**Planning Commission April 25, 2019 Meeting: 7.1**

**Marketplace Final Development Plan - Parcel B (Office and Garage)**

**Reconsideration Hearing**

***Applicant: AG-CCRP Public Market LP***

Figure 1: PDP 2008 and FDP 2019 FDP Massing Studies from West and South-East

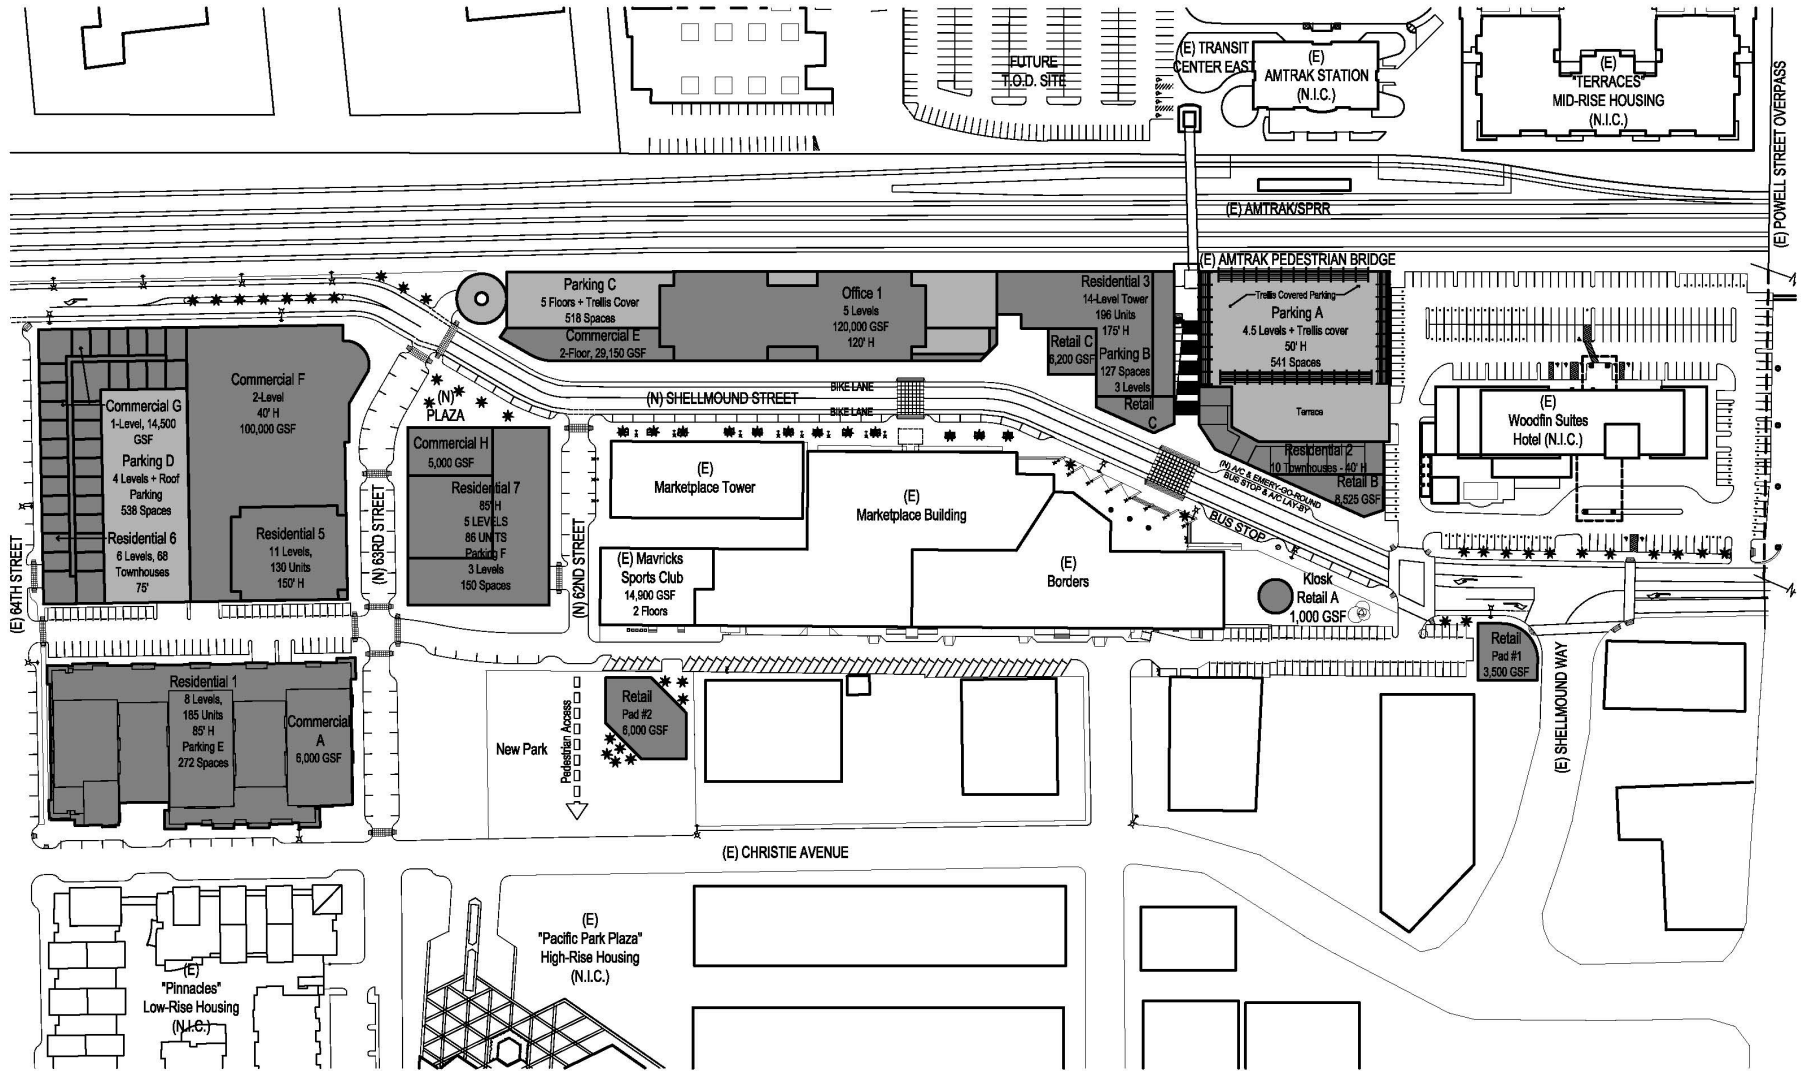
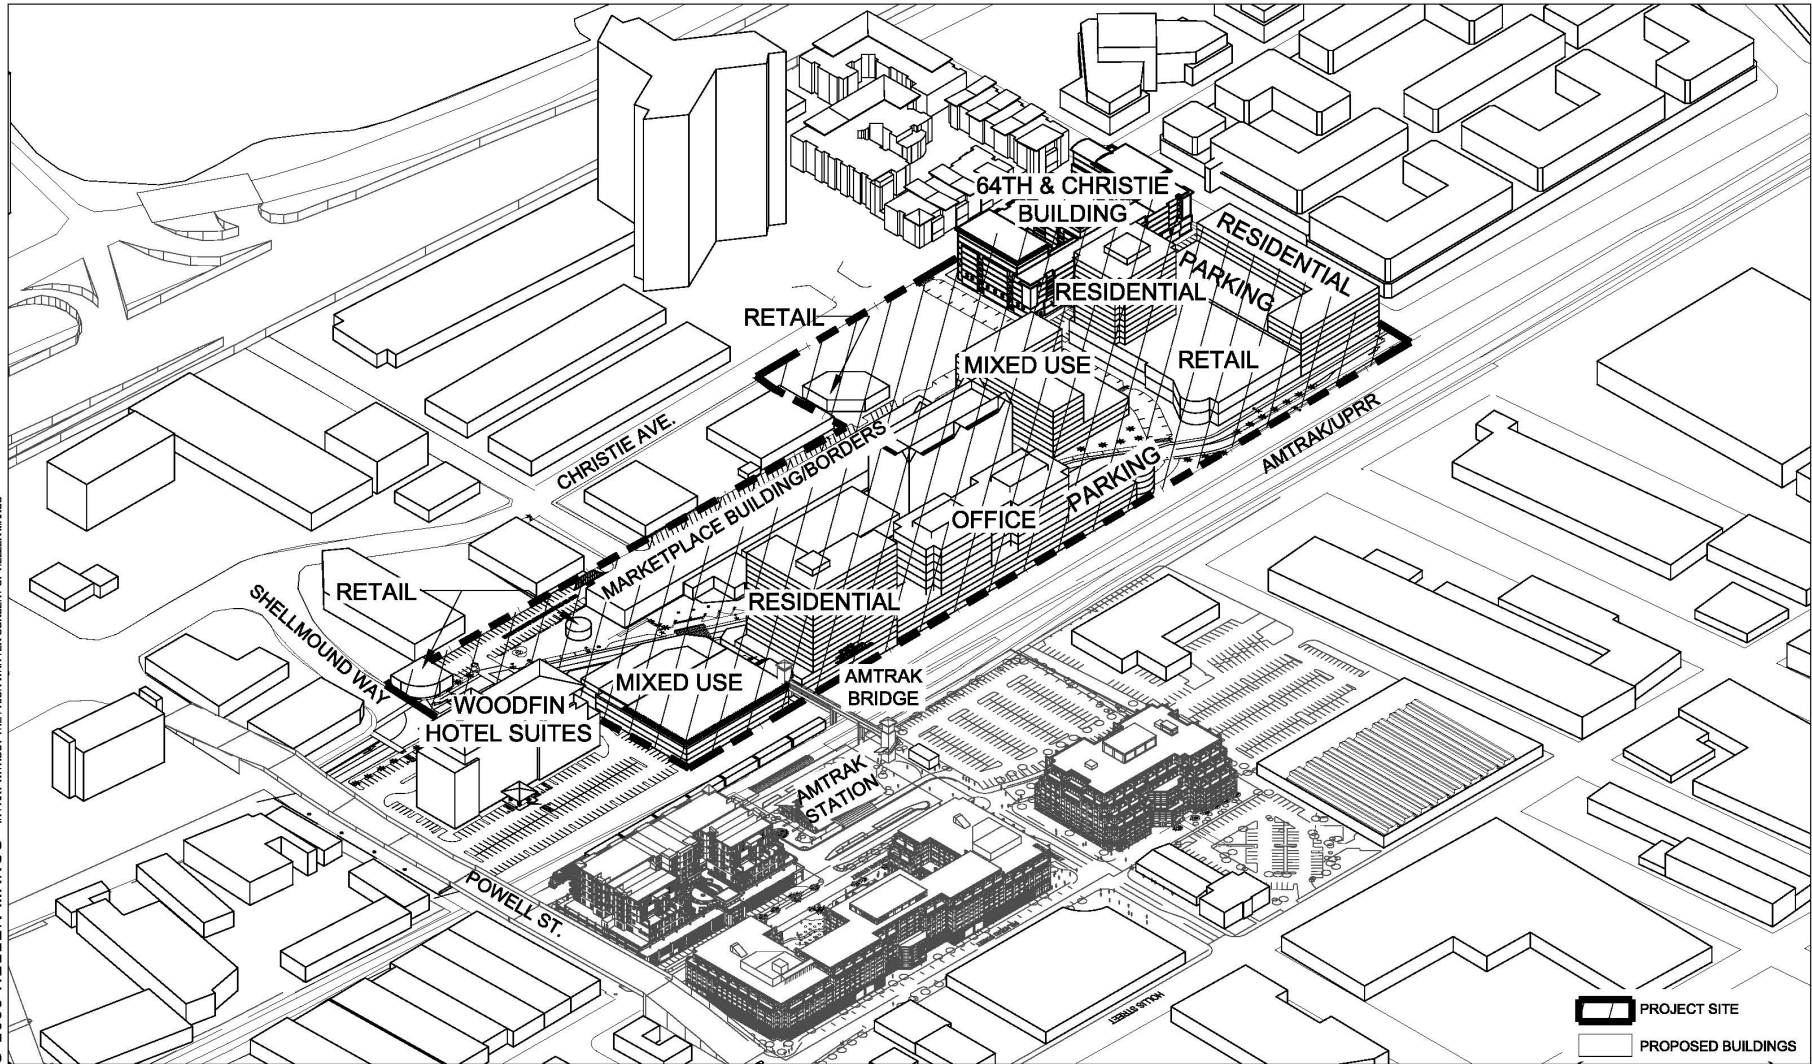
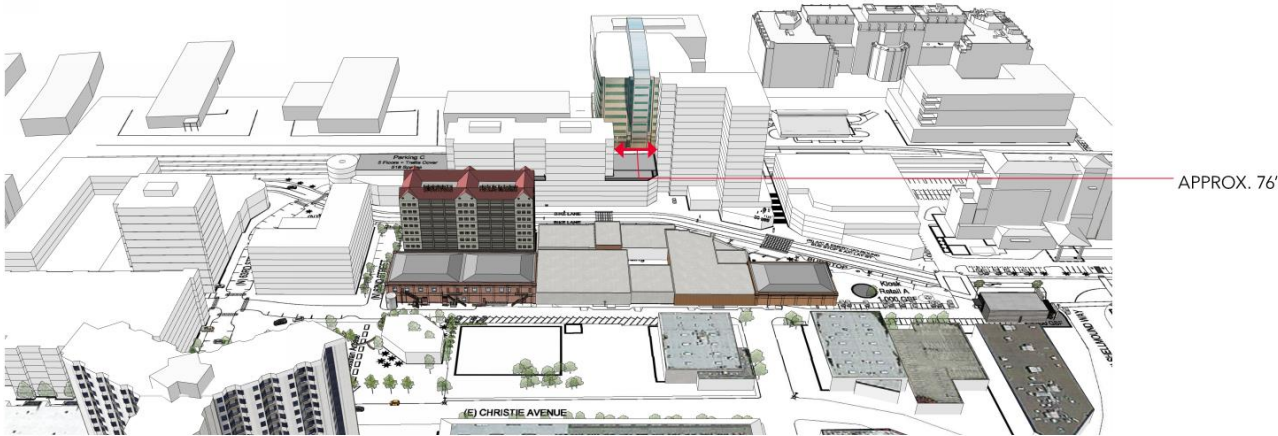
*(1) Requirement AES1 calls for the final designs to create a “vital streetscape that enhances the pedestrian experience, avoid blank walls or box-like forms.” The original 2008 approval indeed included large buildings along the railroad tracks. However, in the original approval they have varying and modulated heights and façade, with several important openings and livable gaps between different building gaps.*

<b>PUD/PDP</b>	<b>FDP</b>
<b>Parcel A</b>	175 feet	86 feet – northern end 50 feet – southern end
<b>Parcel B</b>	120 feet	112 feet

Figure 1: PDP 2008 and FDP 2019 FDP Massing Studies from West and South-East

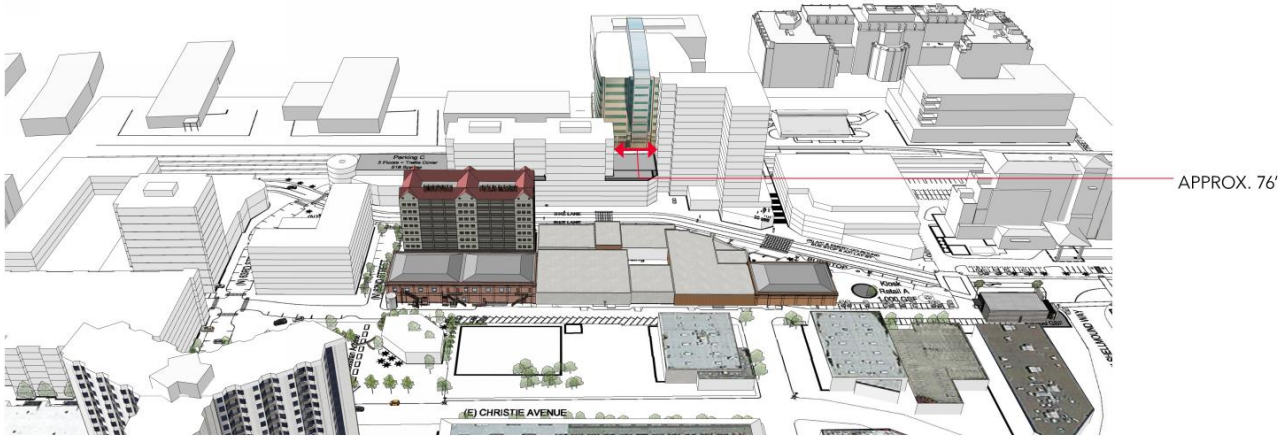
*(3) WIND 1 also specifically says that any Final Design should “avoid narrow gaps between the buildings where winds could be accelerated.” The current design does the exactly the opposite. The prior approved design for Parcel B has roughly 170-foot gap between it and the approved Parcel A.*

- The Commission needs to make a finding that a FDP is consistent with the PUD/PDP; and not that the proposal is consistent with a previously approved project.
